# HISTORIC AND DESIGN REVIEW COMMISSION

**HDRC CASE NO:** 2020-057  
**ADDRESS:** 607 DAWSON ST  
**LEGAL DESCRIPTION:** NCB 561 BLK 1 LOT S 106.6 FT OF E 54.72 FT OF 9 OR A16  
**ZONING:** R-4, H  
**CITY COUNCIL DIST.:** 2  
**DISTRICT:** Dignowity Hill Historic District  
**APPLICANT:** SHILLIG CARTER NEAL & SHILLIG BONNIE J & DEARING JOSEPH  
**OWNER:** SHILLIG CARTER NEAL & SHILLIG BONNIE J & DEARING JOSEPH  
**TYPE OF WORK:** Construction of a 1-story, single family residential structure  
**APPLICATION RECEIVED:** January 22, 2020  
**60-DAY REVIEW:** March 22, 2020  
**CASE MANAGER:** Huy Pham  
**REQUEST:**

The applicant is a request a Certificate of Appropriateness for final approval to construct a one-story, single-family residential structure at 607 Dawson.

SITE PLAN 1/8"=1'-0"

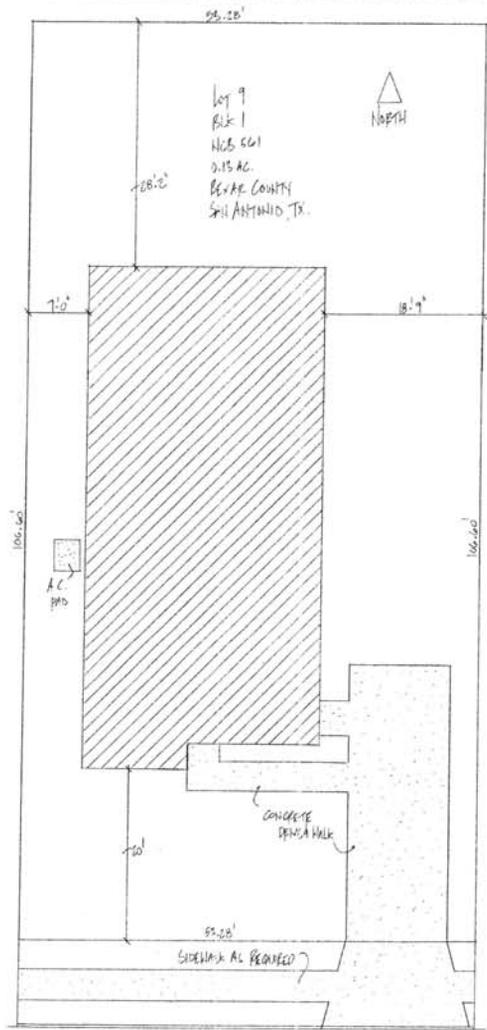
- c. **SETBACKS & ORIENTATION** – According to the Guidelines for New Construction, the front facades of new buildings are to align with front facades of adjacent buildings where a consistent setback has been established along the street frontage. Additionally, the orientation of new construction should be consistent with the historic examples found on the block. The applicant has proposed a front setback of 20 feet from the property line, which staff approximates at 23 feet from the public sidewalk. Staff finds that the front façade should be set behind the adjacent structure and that a comprehensive setback diagram be submitted to staff. Regarding the structure’s orientation, the applicant has proposed an orientation that is consistent with those found historically on the block.

- m. DRIVEWAY– The applicant has proposed a poured concrete driveway fronting Dawson with a concrete walkway connecting to the front porch. Staff finds the location of the proposed driveway to be appropriate; however, the width of the proposed driveway should not exceed ten (10) feet in width.

- n. FRONT WALKWAY – The applicant has proposed to install a poured concrete walkway connecting from the driveway to the front porch. The Guidelines for Site Elements note that front yard sidewalks should appear similar to those found historically within the district in regards to their materials, width, alignment and configuration. Staff finds that a linear poured concrete walkway connecting from the public sidewalk to the front porch, and then decomposed granite or stepping stone path from the central walkway to the driveway would be more appropriate and relate to historic site elements in the historic district.

- i. That the front façade should be set behind the adjacent structure and that comprehensive setback diagram is submitted to staff, as noted in finding c.

- vii. That the width of the proposed driveway should not exceed ten (10) feet in width.
- viii. That a linear poured concrete walkway connecting from the public sidewalk to the front porch, and then decomposed granite or stepping stone path from the central walkway to the driveway would be more appropriate and relate to historic site elements in the historic district.
